TECHNICAL BULLETIN

HEAT/DEFOG UPPER DECK THROUGH FITTING MODIFICATION

MD900 helicopters, serial number 900-00002 thru 900-00051.

900P2250205 Line Assembly, Heat/Defog-CHK Valve to Deck and 900P2250209 Tube Assembly, Heat/Defog-Roof to Valve.

Figure 1. Heat/Defog Modification

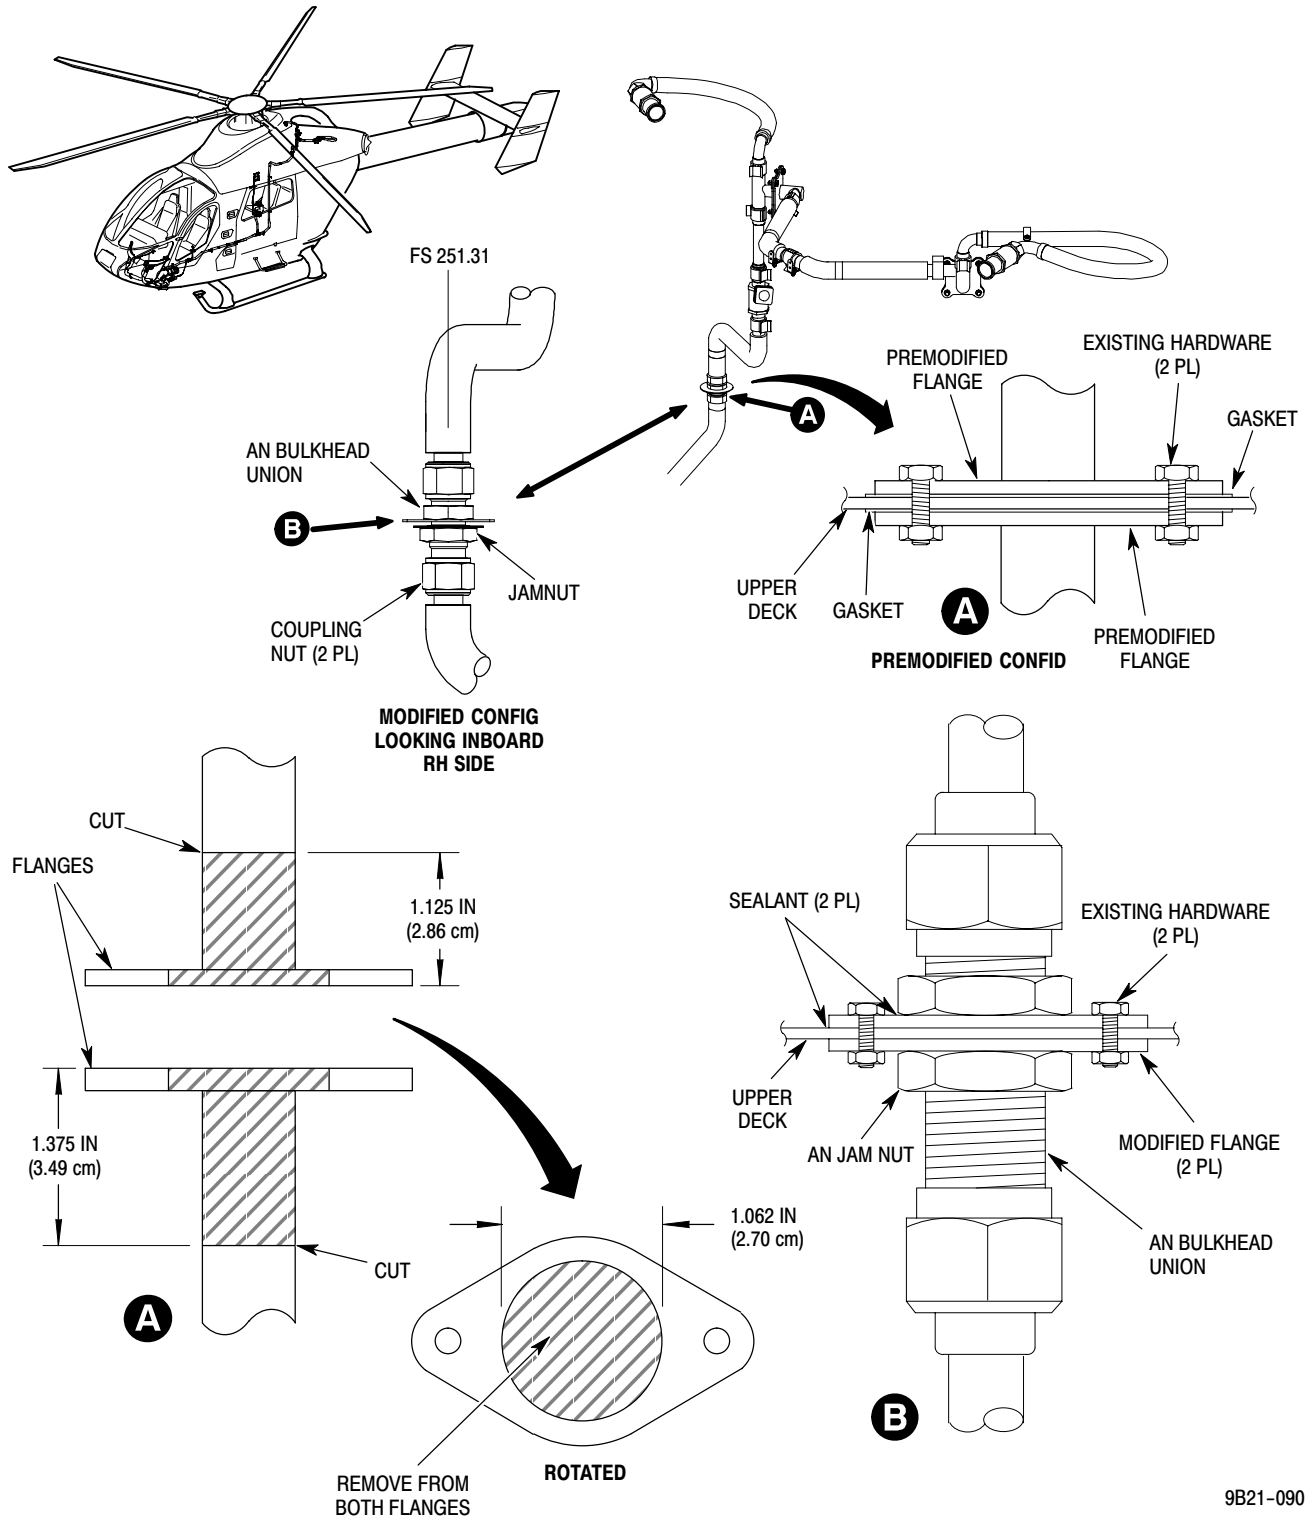
Aircraft in the field have experienced bleed air leaks at the upper deck heat/defog through fitting. This causes loss of heating efficiency and failure to pass the heat/defog leak test.

Procedures in this Bulletin provide owners and operators with instructions to replace their existing bleed air through fitting with an AN flared bulkhead union and jam nut. This modification requires flaring of the ends of the affected line and tube assemblies.

- (1). Access heat/defog system at FS 251.31 above and below the upper deck (Ref. CSP-900RMM-2, Section 21-40-00).
- (2). Remove 900P2250205 line assembly and 900P2250209 tube assembly (Ref. CSP-900RMM-2, Section 21-40-00).
- (3). Remove seal assemblies from ends of tube and line assemblies and discard.
- (4). Remove gaskets from above and below upper deck and discard.
- (5). Measure and mark the 900P2250205 line assembly **1.125 in. (2.86 cm)** from flange end.
- (6). Measure and mark the 900P2250209 tube assembly **1.375 in. (3.49 cm)** from flange end.

- (7). Cut the line and tube assemblies at the marks, and deburr.
- (8). Install one (1) each sleeve and coupling nut on each cut tube, and flare in accordance with MS33584 for **0.75 in. (19.05 mm)** tube.

- (10). Modify both removed flanges by removing all remaining tubing.
- (11). Enlarge hole in both flanges to **1.062 in. (2.70 cm)** in diameter and deburr.
- (12). Clean both sides of upper deck and both modified flanges with Desoclean 45 or equivalent and blow dry with filtered compressed air.

- (13). Reinstall flanges wet with fireproof sealing compound and original hardware. Torque bolts **36-46 in. lb. (4.0-5.2 N•m)**.
- (14). Clean AN bulkhead union and jam nut with Desoclean 45 or equivalent and blow dry with filtered compressed air.

- (15). Install bulkhead union through flanges, coat upper threads with thread locking compound and install jam nut. Torque jam nut **500-600 in. lb. (56.48-67.77 N•m)**.

- (18). Reinstall modified line and tube assemblies (Ref. CSP-900RMM-2, Section 21-40-00). Torque coupling nuts **500-600 in. lb. (56.48-67.77 N•m)**.
- (19). Perform Heat/Defog System Leak Check (Ref. CSP-900RMM-2, Section 21-40-00).
